REMARKS

U.S. Application No. 09/625,201

FIG. 1(a)

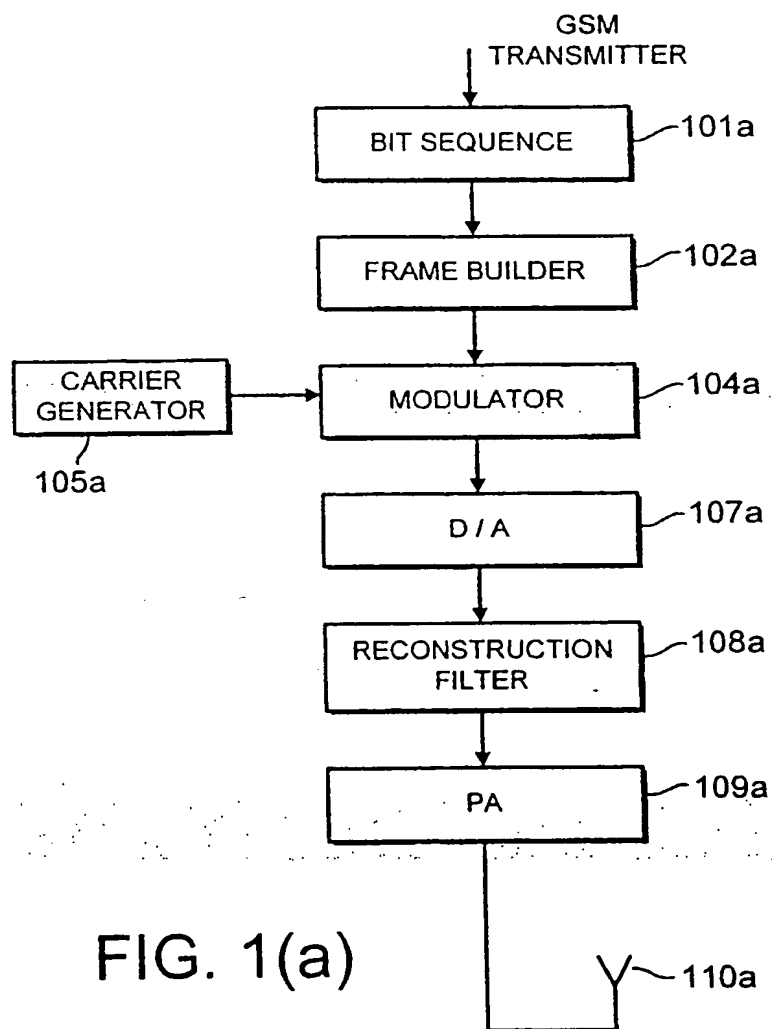
Figs. 1(a) - 1(c) and 9 have been objected to, as the Examiner requires that a legend such as "Prior Art" be included. Applicant has amended these figures to further clarify the invention and respectfully request that these objections be withdrawn.

PRIOR ART

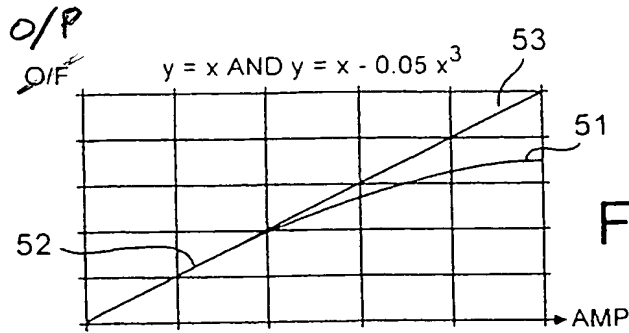
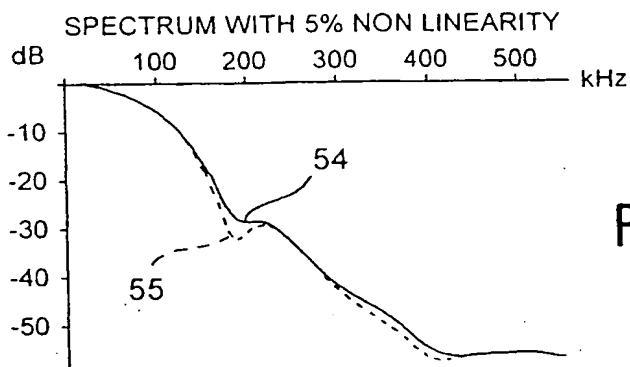
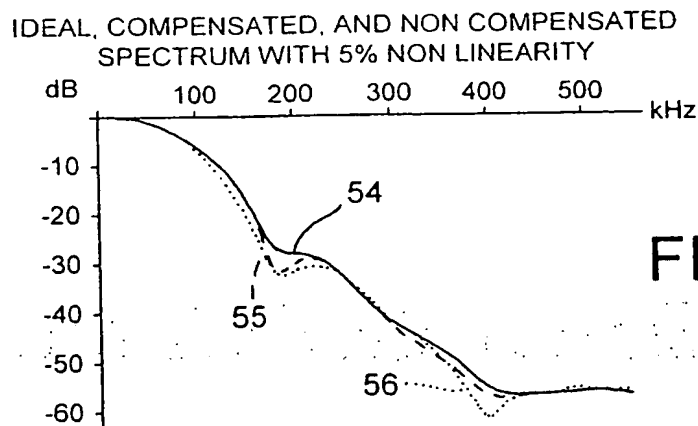
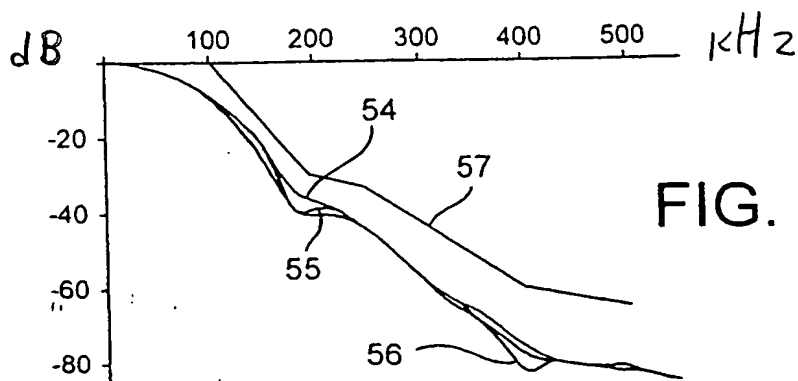
Figs. 5(a) - 5(d), 6(a) - 6(f), 9 and 10 have been objected to since the axes do not have labels. Applicants submit that Figs. 5(b) and 5(c) have appropriate labels "dB" and "kHz" on the y-axis and x-axis, respectively. Applicants have amended the figures without labels to further clarify the invention and respectfully request that these objections be withdrawn.
